SUBJECT: Advises that addl secondary <sup>see Repuls</sup> containment bypass leakage paths identified as result of final verification of pipe whip studies, changing accident analysis for offsite doses. W/ eight oversize encl & 27 oversize drawings.

June 30, 1986  
(NMP2L 0761)

Re: Nine Mile Point Unit 2  
Docket No. 50-410

FIGURE 6.2-88

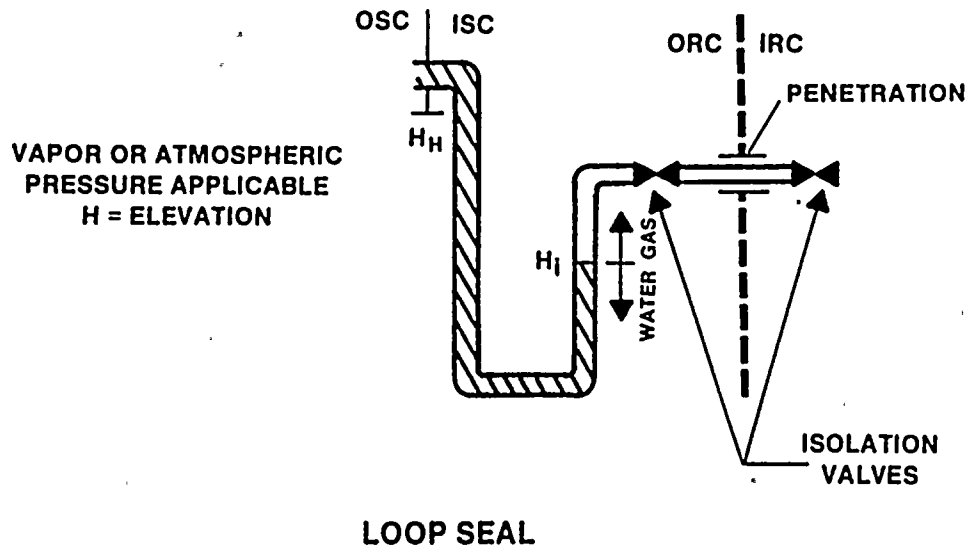
Several process lines eliminate bypass leakage by the use of water seals. These are discussed below and include condensate makeup and drawoff (CNS), reactor core isolation cooling (RCIC) and high pressure core spray (HPCS). Feedwater system (FWS) is also discussed below, but no credit for water seals is applied for that system. A typical loop seal is shown on Figure 6.2-88.
